MEMBER REPORT

1st Floor, FC1: J1 (i1464)

Job Notes TC 156058 544 DUNCAN CREEK ROAD LILLINGTON, NC, 27546 DUNCAN'S CREEK 155

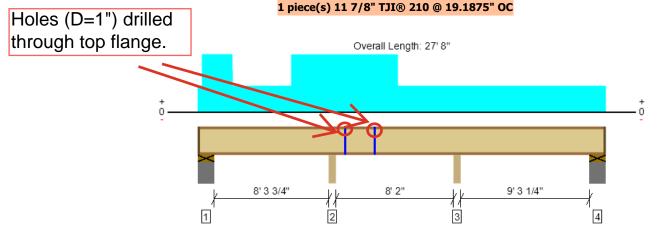
Shear (lbs)		Moment (Ft-Ibs)		Deflection (in)				
Location Analysis	Actual	Allowed	LDF	Actual	Allowed	LDF	Live Load Total		Comments
1 - 10'									1" hole drilled through top flange
2 - 12'									1" hole drilled through top flange

Member with damage as shown (and repaired if required) has adequate structural capacity for the design condition indicated. I have not reviewed the project plans or field conditions. The proper authority is to review the damage evaluation inputs and confirm they are consistent with the intent of the overall building design and field conditions. This damage evaluation is based on the information provided to Weyerhaeuser; if not consistent with the building design and field conditions, it should be rejected or returned to us to be corrected.
